Bill Mundy, Ph.D., MAI
Chairman, Canterbury Shores SR520 Committee
2500 Canterbury Lane E., #301
Seattle, WA. 98112
bill@mundyfarms.com
mamundy@comcast.net
April 1, 2010

Jenifer Young
SR520, I-5 to Medina: Bridge Replacement and HOV Project
Environmental Manager
SR520 Project Office
600 Stewart Street, Suite 520
Seattle, WA., 98101

The following are comments from the Canterbury Shores Condominium regarding the SR520 Supplemental Draft Environmental Impact Statement (SDEIS), January 2010. Canterbury Shores is a 92 unit condominium located on the Northern Shore of North Madison Park. The comments that follow have been reviewed and approved by the Canterbury Shores Board of Directors.

EXHIBIT 2

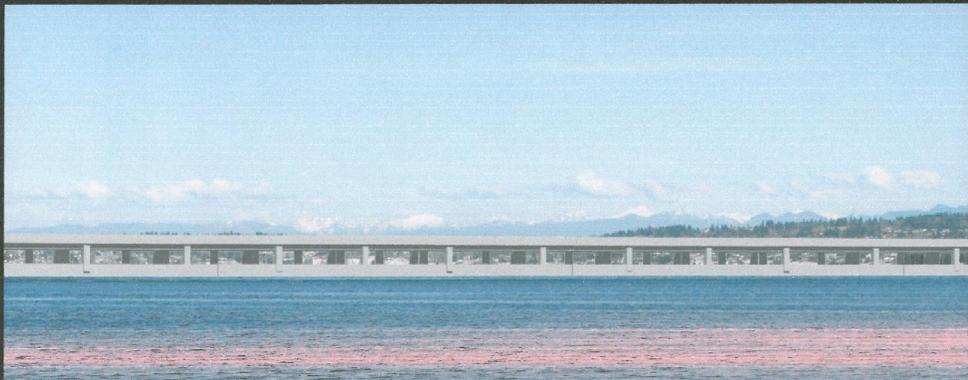
Exhibit 2-17 and 2-18 show existing and Option A (and the 2 other options also) views. Both exhibits are MISLEADING due to the INCORRECT way the photographs were taken (using an incorrect camera lens that does NOT show what the eye actually sees). Exhibit 2 shows what the view will actually be like from the north shore of NMP on a before and after basis. Exhibit 3 shows what the views will look like from the Madison Park street end pier. These two exhibits were prepared by a professional photographer, Mr. Aaron Weholt, Legal Media, Seattle, WA.

Volume 1: Because there are more views in the project area than could be modeled, viewpoints are carefully selected to capture typical, representative views. Exhibit 2-17 is representative of the views from the north shoreline of Madison Park. As can be seen in this exhibit, the view under the new bridge extends farther across the water than the view of the existing bridge. Exhibits 2-19 and 2-20 illustrate the view from Laurelhurst and show the north Madison Park shoreline.

Volume 2: It is an accepted industry standard to use the focal length used for these images (roughly 35 mm depending on the camera) because the view is wide but without distortion at the outer edges. The SDEIS visualizations were created by graphics artists who specialize in creating 3-D models based on engineering designs and placing the 3-D models in photographs.
